West Sussex County Council
East Grinstead Stage 3 Traffic
Management Study

Stage 1 Road Safety Audit
February 2012

Project: East Grinstead Stage 3 Traffic Management Study **To:** Chris Owen

Subject: Stage 1 Safety Audit Response Report **From:** John Malyon

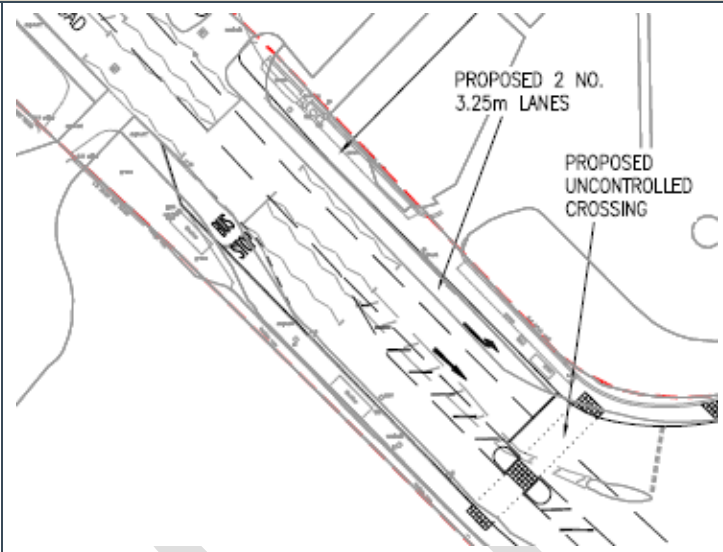
Location Reference No: 10	
<p>Location: Eastern back of footway on A22 London Road (Drg No: 5107918/TP/PD/201)</p>	
<p>Problem:</p>	<p>General - Proximity of building edge to highway boundary</p>
<p>Summary:</p>	<p>The proposal shows the back of the footway to be in close proximity to the corner building edge and could be close to building services that have not been designed to withstand live traffic loading. Damaged services could cause severe maintenance issues both for adjacent properties and the general public, which in turn could lead to vehicle conflicts if failure of services/ highway occurs.</p>
<p>Recommendation:</p>	<p>Ensure that there is sufficient clearance between the back of footway and the building edge and that any private service within this area is protected or redesigned to take any additional loading.</p>

Location Ref.	Problem	Recommendation	Accepted/ Rejected	Designer's Response
	<p>London Road (Drg No: 5107918/TP/PD/201)</p> <p>Problem: General - Proximity of building edge to highway boundary</p> <p>Summary: The proposal shows the back of the footway to be in close proximity to the corner building edge and could be close to building services that have not been designed to withstand live traffic loading. Damaged services could cause severe maintenance issues both for adjacent properties and the general public, which in turn could lead to vehicle conflicts if failure of services/ highway occurs.</p>	<p>footway and the building edge and that any private service within this area is protected or redesigned to take any additional loading.</p>		<p>will investigate further the potential services that may be affected and that will require protection / diversion</p>
11	<p>Location: Eastern footway at A22 London Road/Imberhorne Lane junction (Drg No: 5107918/TP/PD/201 & 202)</p> <p>Problem: Non Motorised User Provision - Insufficient footway width on northern footway</p> <p>Summary: The proposal does not show the location of the traffic signal pole or proposed street furniture, however it would be expected that at least the traffic signal pole would be placed at the front of the footway to accommodate any pedestrian crossing at this location. This would reduce the footway width even further than is proposed, making it difficult for wheelchair users and people with pushchairs to make safe use of the footway. This could lead to pedestrians encroaching into the carriageway and being in conflict with vehicles.</p>	<p>Consider additional widening of the footway.</p>	Rejected	<p>The proposed footway width (2m) is greater than the existing footway width and meets the requirements for minimum preferred obstacle free footway width in the DfT Inclusive Mobility guide. The minimum obstacle free width of 1.5m should be maintained at signal poles. Wider footways could be provided but this would require additional third party land and would need to be balanced against expected pedestrian demand.</p>

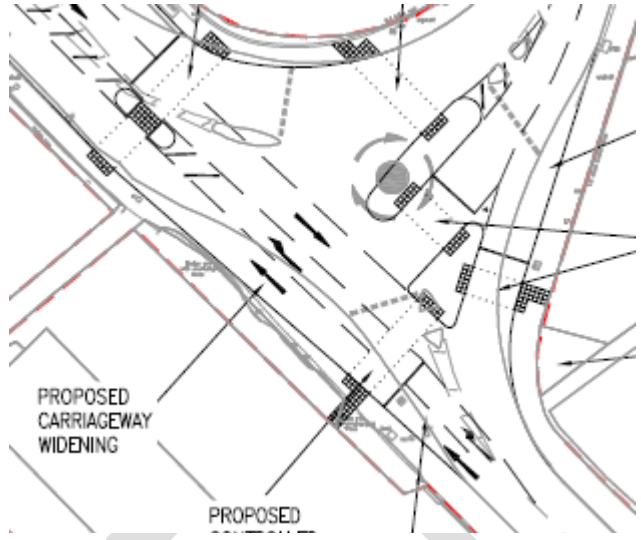
Location Reference No: 11	
Location: Eastern footway at A22 London Road/Imtherhorne Lane junction (Drg No: 5107918/TP/PD/201 & 202)	
Problem:	Non Motorised User Provision - Insufficient footway width on northern footway
Summary:	The proposal does not show the location of the traffic signal pole or proposed street furniture, however it would be expected that at least the traffic signal pole would be placed at the front of the footway to accommodate any pedestrian crossing at this location. This would reduce the footway width even further than is proposed, making it difficult for wheelchair users and people with pushchairs to make safe use of the footway. This could lead to pedestrians encroaching into the carriageway and being in conflict with vehicles.
Recommendation:	Consider additional widening of the footway.

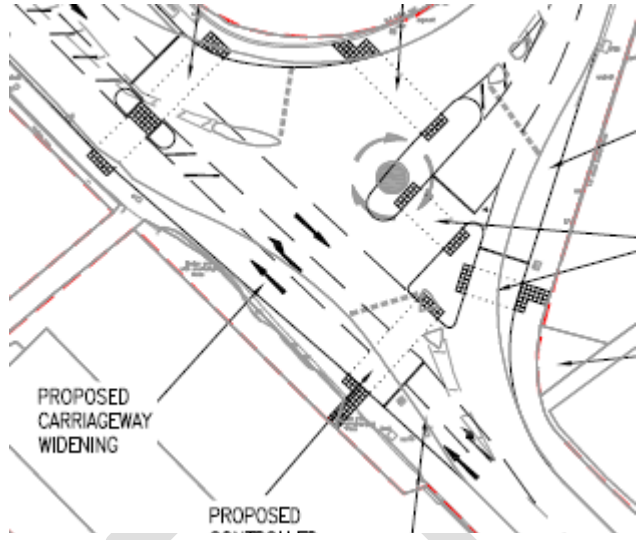
Location Reference No: 12	
<p>Location: Northbound approach and exit to junction on A22 London Road (Drg No: 5107918/TP/PD/201 & 202)</p>	
<p>Problem:</p>	<p>Junctions - A22 London Road Northbound alignment</p>
<p>Summary:</p>	<p>The proposed alignment does not take into account the vehicle desire lines. Vehicles in the offside lane travelling straight on the A22 London Road will be guided into the pedestrian island and eastern kerbline on exiting the junction. If a vehicle were to travel through the junction at speed and the driver was to misjudge the carriageway alignment, this could lead to a vehicle/pedestrian conflict on the island or collision of the vehicle with street furniture on the footway.</p>
<p>Recommendation:</p>	<p>Improve the alignment for vehicles travelling northbound.</p>

12	<p>Location: Northbound approach and exit to junction on A22 London Road (Drg No:</p>	<p>Improve the alignment for vehicles travelling northbound</p>	Accepted	<p>The traffic island has been relocated to provide greater lane widths for northbound</p>

Location Ref.	Problem	Recommendation	Accepted/ Rejected	Designer's Response
	<p>5107918/TP/PD/201 & 202)</p> <p>Problem: Junctions - A22 London Road Northbound alignment</p> <p>Summary: The proposed alignment does not take into account the vehicle desire lines. Vehicles in the offside lane travelling straight on the A22 London Road will be guided into the pedestrian island and eastern kerblines on exiting the junction. If a vehicle were to travel through the junction at speed and the driver was to misjudge the carriageway alignment, this could lead to a vehicle/pedestrian conflict on the island or collision of the vehicle with street furniture on the footway.</p>			<p>traffic with the kerb alignment of the proposed island designed to guide vehicles through the junction without conflict. This can be reviewed at the next stage of design when a more detailed topographic survey should be available..</p>
